DRAINAGE AND TRANSPORTATION INFORMATION SHEET

RE: GOLF COURSE + WESTSIDE COMMERCIAL SUBDIVISION
10850 GOLF COURT RD. NW
ENGINEER'S STAMP DATE: 9/14/22
HYDROLOGY FILE: A12D008B2

Per the correspondence dated October 11, 2022, please find the following responses addressing the comments listed below:

DRAINAGE REPORT FOR

Plat of
Tracts D-1-A, D-1-B, D-1-C and D-1-D
Paradise Heights, Unit 1
Section 1, Township 11 North, Range 2 East, N.M.P.M.
Albuquerque, Bernalillo County, New Mexico
October 2022

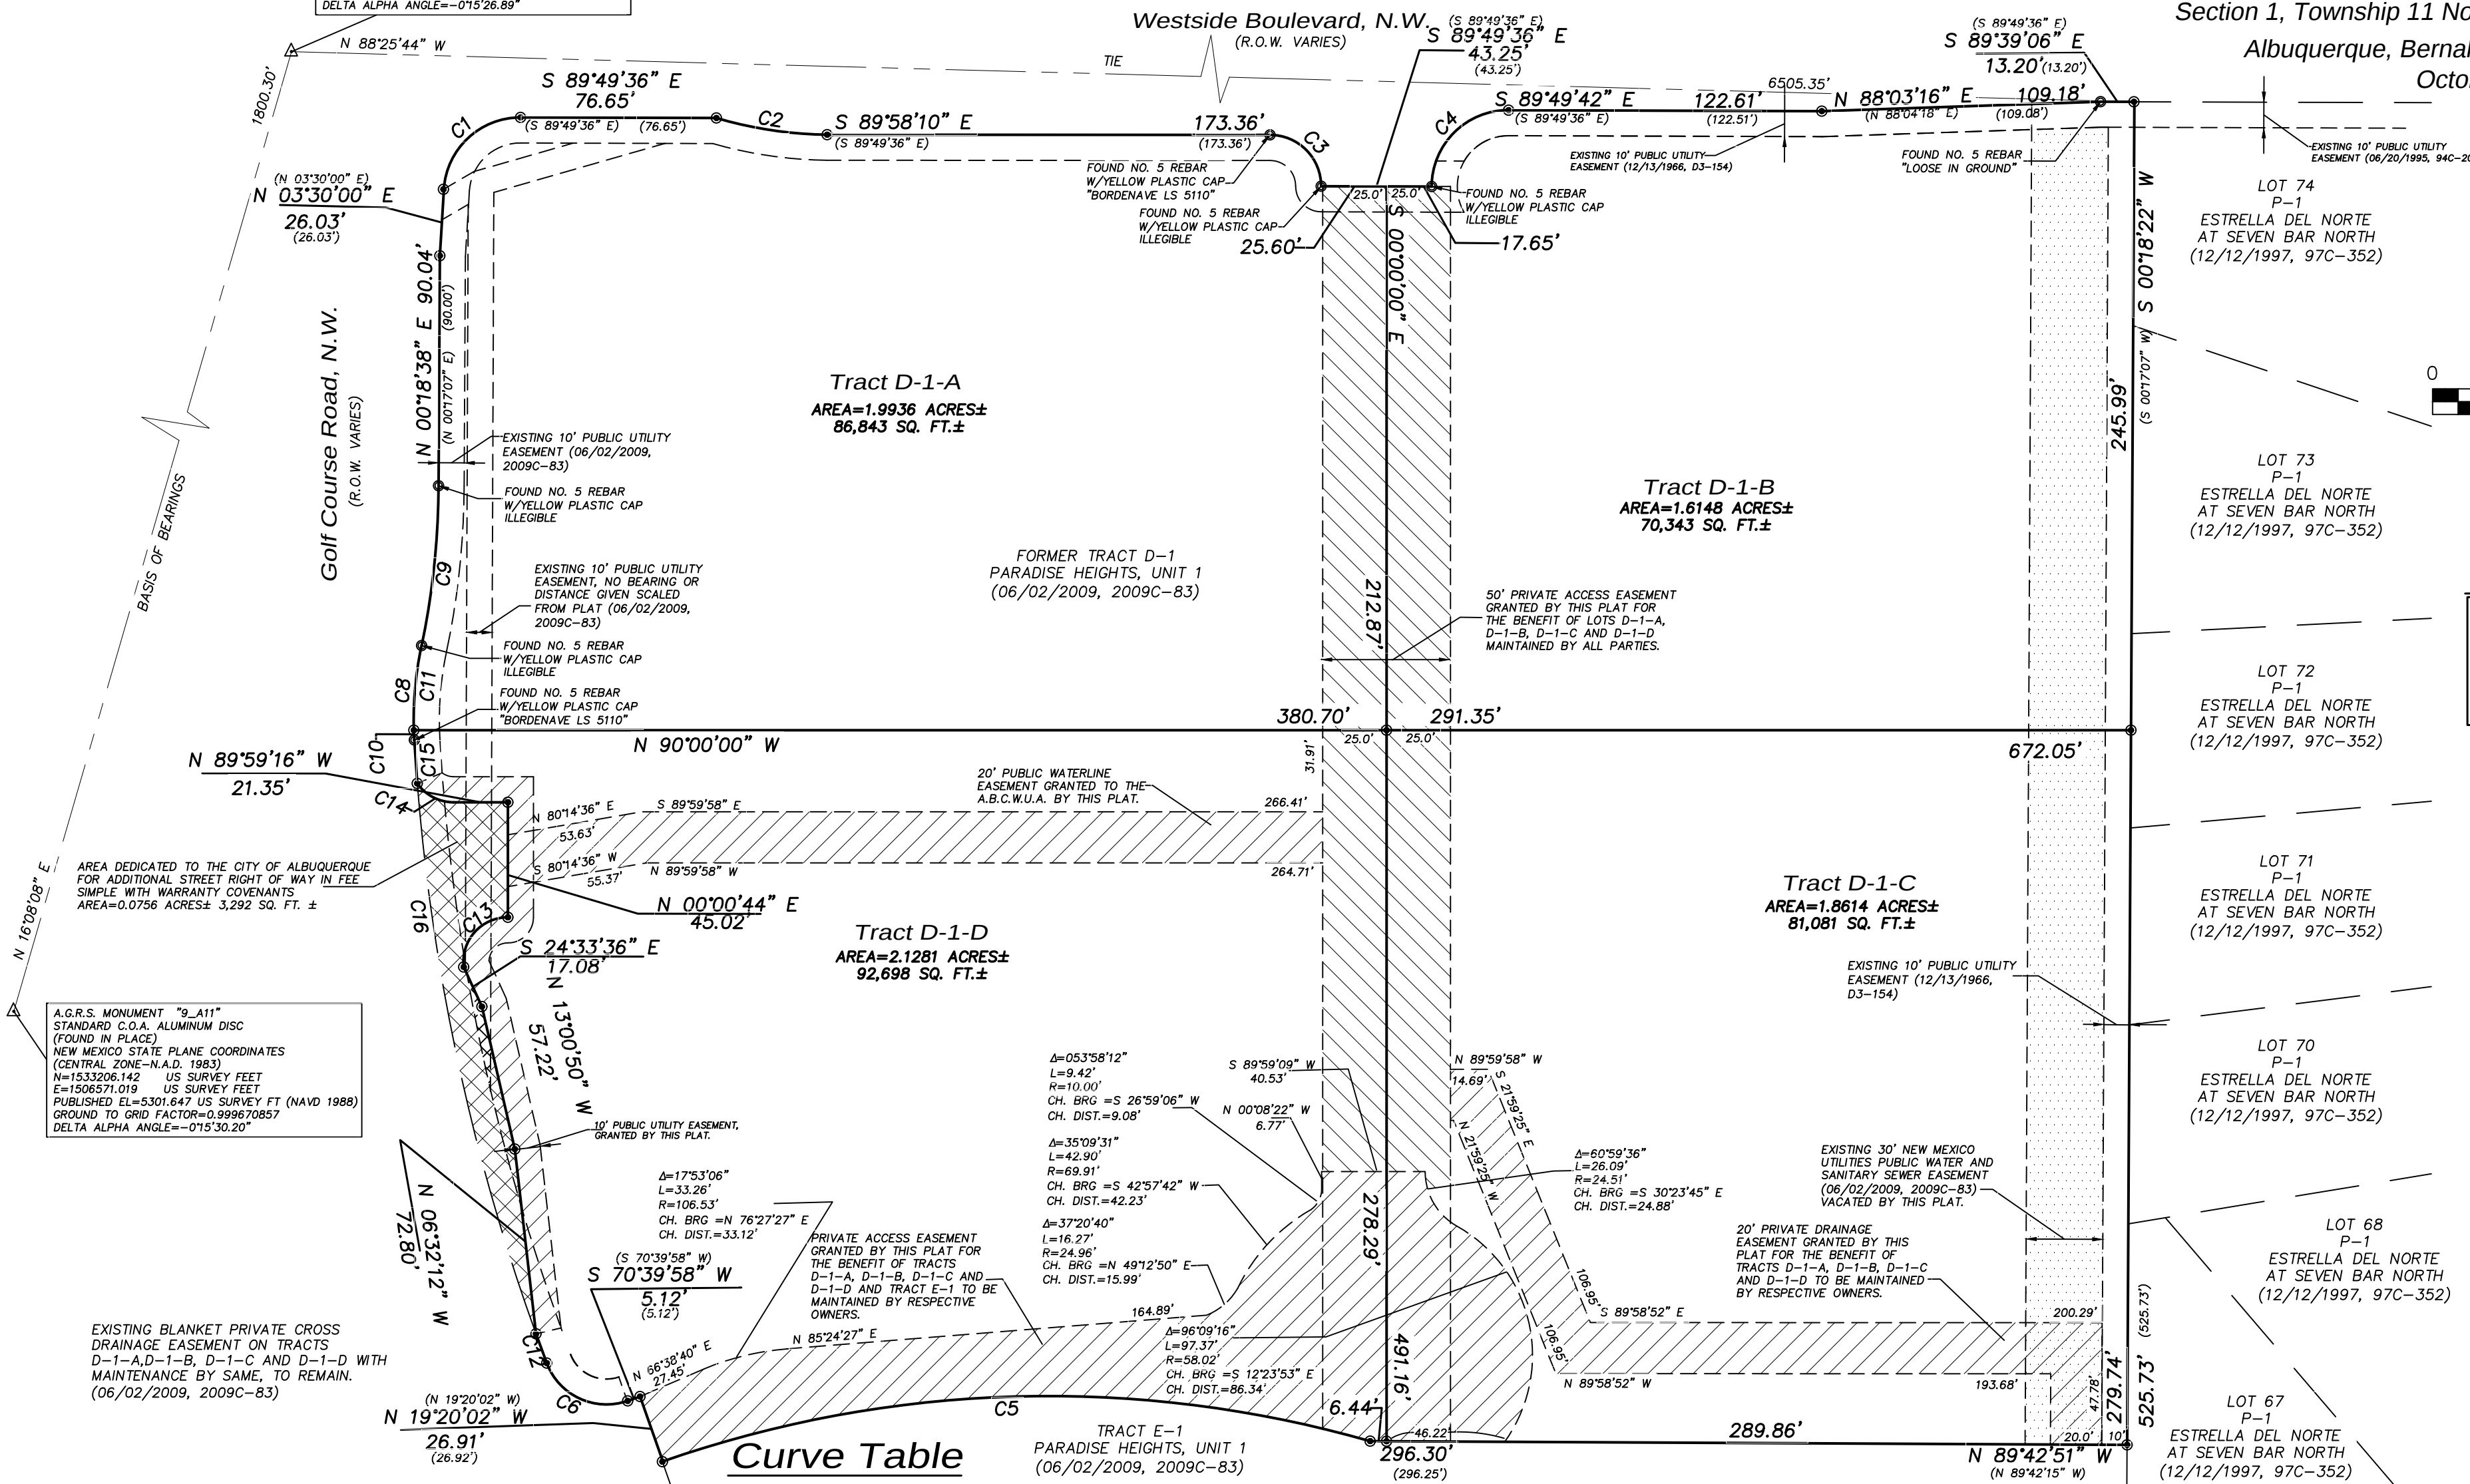
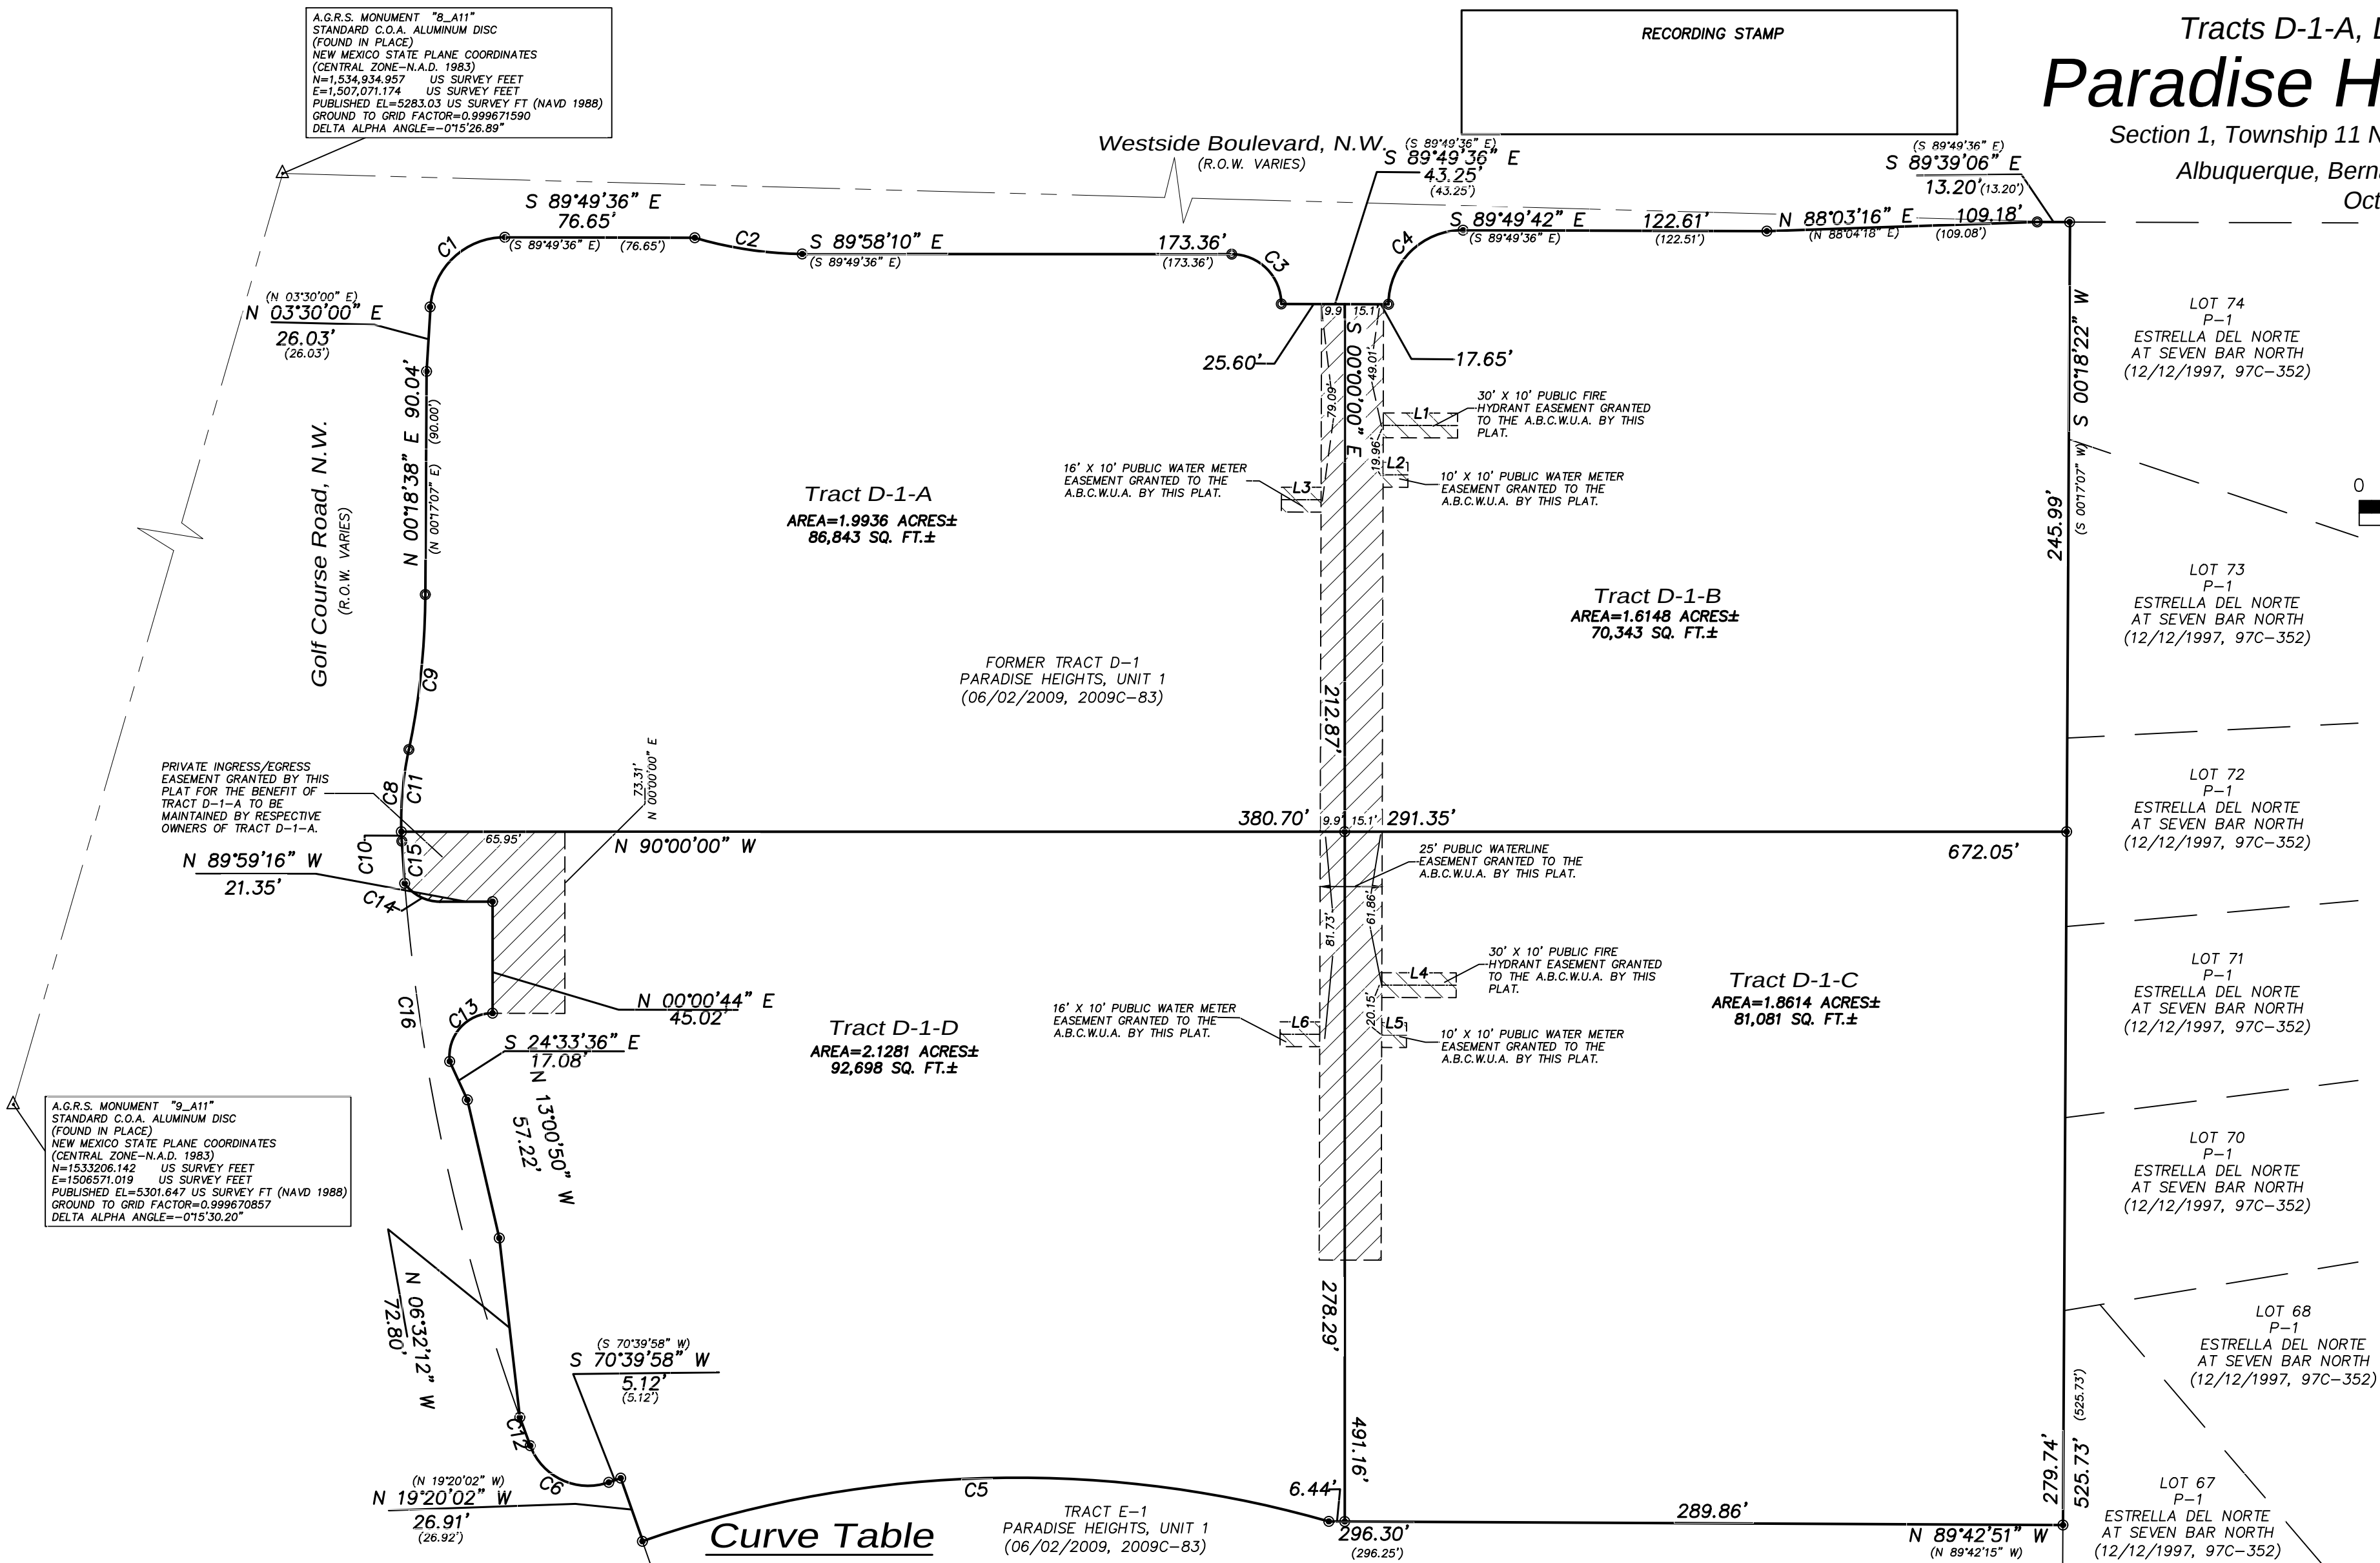
5. Drainage easements, including beneficiary and maintenance responsibilities, must be shown on the Preliminary Plat and on the Grading Plan. Provide similar documentation for the offsite downstream drainage easement.

RESPONSE: Acknowledged, Preliminary plat with easements added to end of report pending DRB approval.
